CASE HISTORY (List any current or prior project and case number(s) that may be relevant to your request.)		
Project # PR-2023-008085, SI-2023-00065 - Site Plan- EPC

Project # PR-2023-008085
SI-2023-00065 - Site Plan- EPC

Consensus Planning Inc., agent for Las Ventanas NM, Inc., requests a Site Plan- EPC for all or a portion of Tract A-1, Spanish Walk Subdivision, located on Camino Español NW, north of Solar Rd. and west of 4th St., zoned PD, approximately 2.5 acres (E-14)
Staff Planner: Megan Jones

To: Megan Jones, Senior Planner, City of Albuquerque

1 SIGN SCALE: N.T.S.

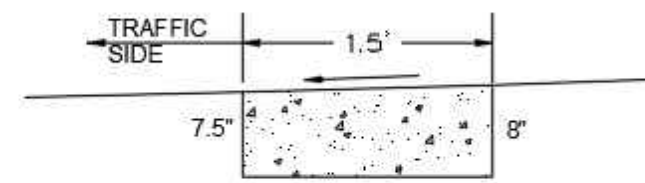
- A. Signage area calculations shall be provided.
- B. Signage details shall be added to the elevations.
- C. The note regarding final sign design to be determined by owner shall be removed.
(Note: What the EPC approves is what will be required unless you go through an Administrative Amendment for the sign).

Not applicable. The signage has been indicated on the Site Plan as keyed note 7 and is listed on the detail sheet as detail 1. The size of the sign is also indicated on the detail sheet.

4 COYOTE FENCE SCALE: 1/2"=1'-0"

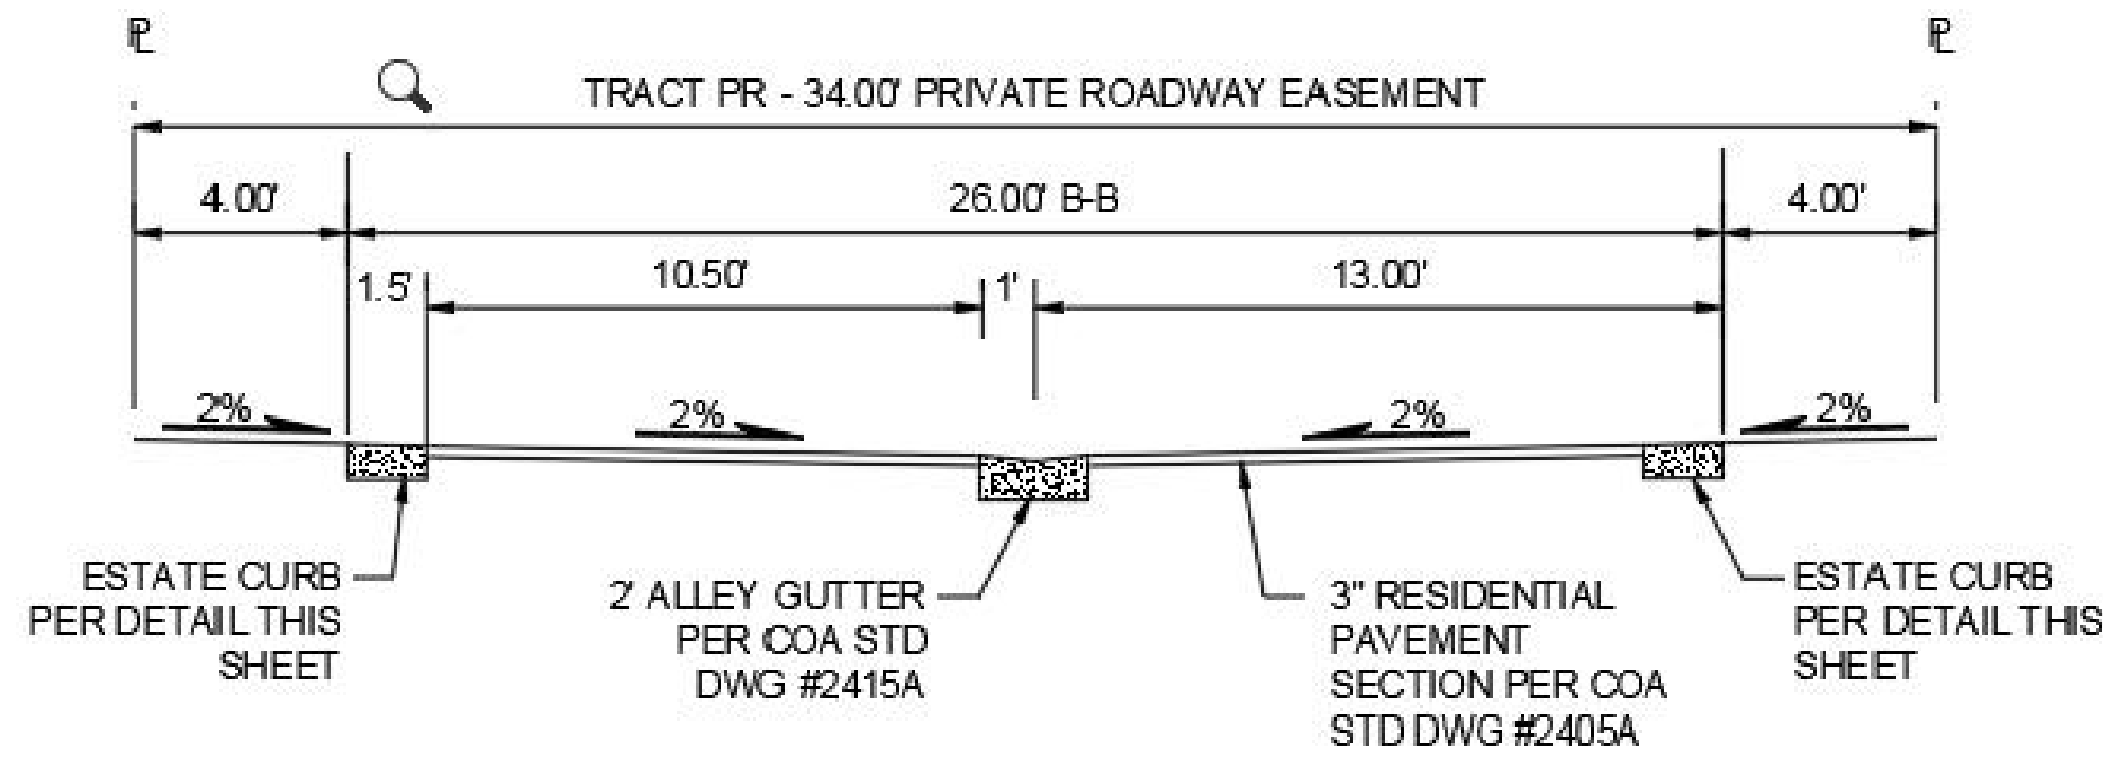
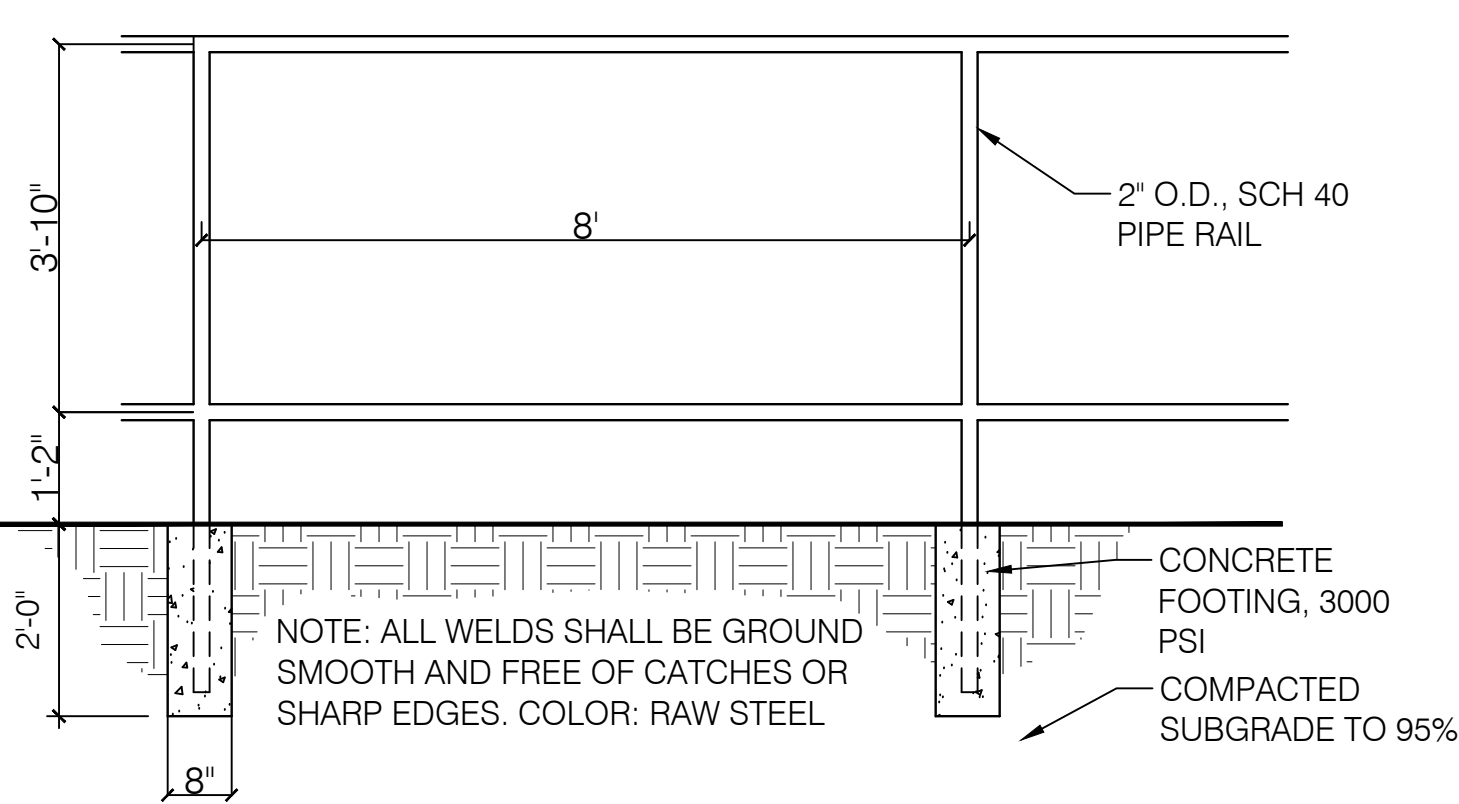
- A. The perimeter wall along Camino Español NW shall match the existing design and character of other walls and fences in the neighborhood (ex. coyote fencing) to comply with the agreement made with the Camino Español HOA.
- B. The site plan shall show the modified perimeter wall along Camino Español NW.
- C. All materials and colors shall be shown on the wall/fence detail.
- D. The perimeter coyote fence shall provide articulation.
